Supplement to the 2010 Urban Design Guidelines for the 2010 Great Seneca Science Corridor Master Plan

Staff Report Date: 1/20/16

LOOP TRAIL

DESIGN GUIDELINES

DRIVE CROSSINGS, GATEWAYS AND INTERSECTIONS

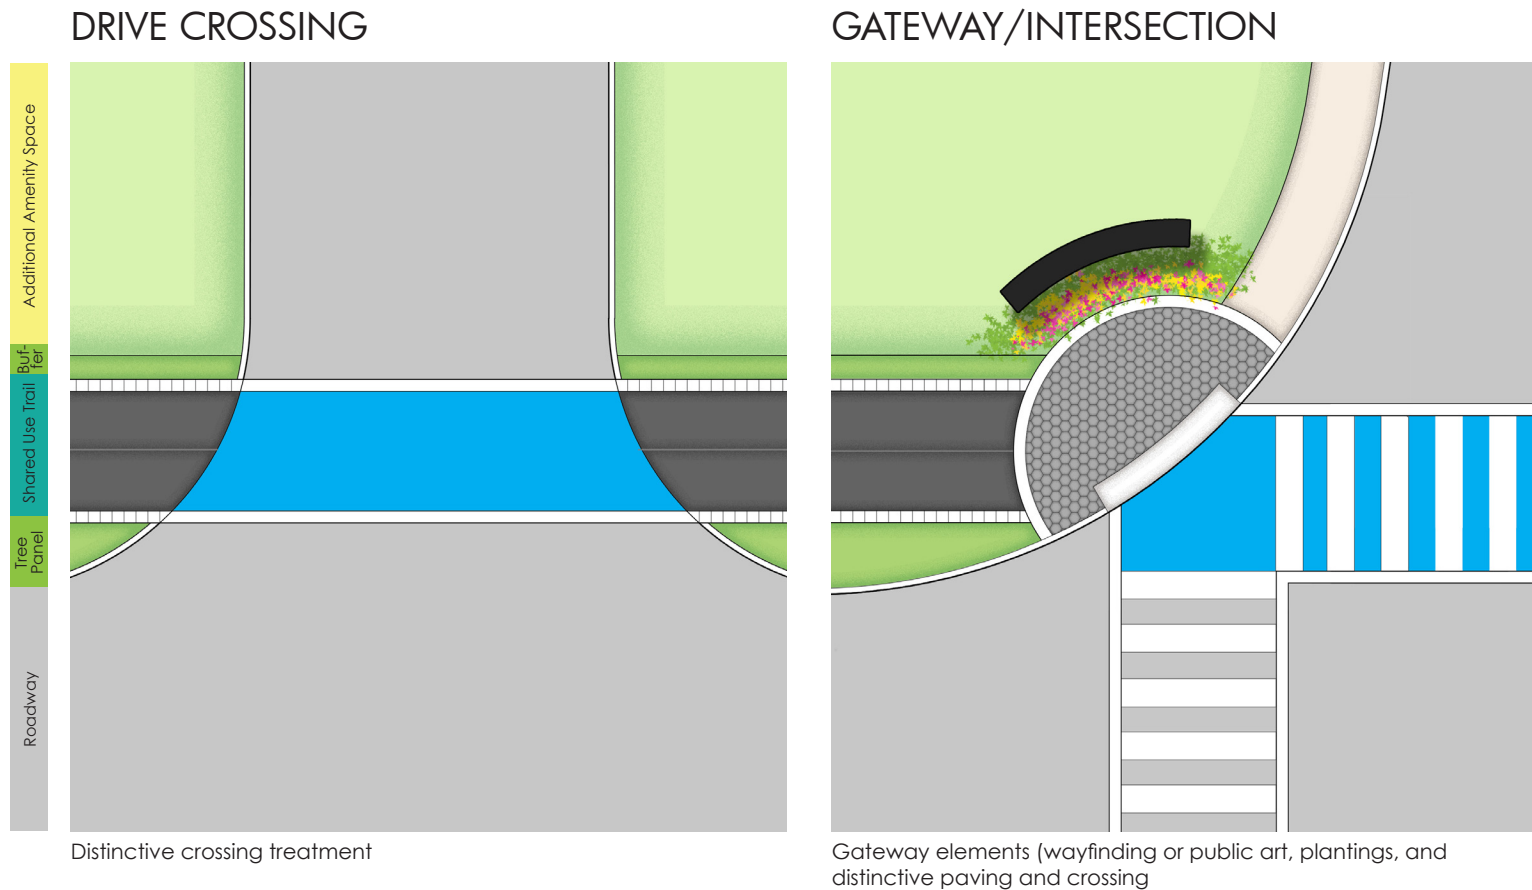
14.	Crosswalk color	Public Comment	Page 19, titled “Drive Crossings, Gateways, and Intersections,” the crosswalk colors should be green, not blue. Green is likely the color to be adopted in the next edition of the Federal MUTCD. Blue is reserved for disabled uses.	Agreed. Pavement marking and striping will be determined in the facility plan.
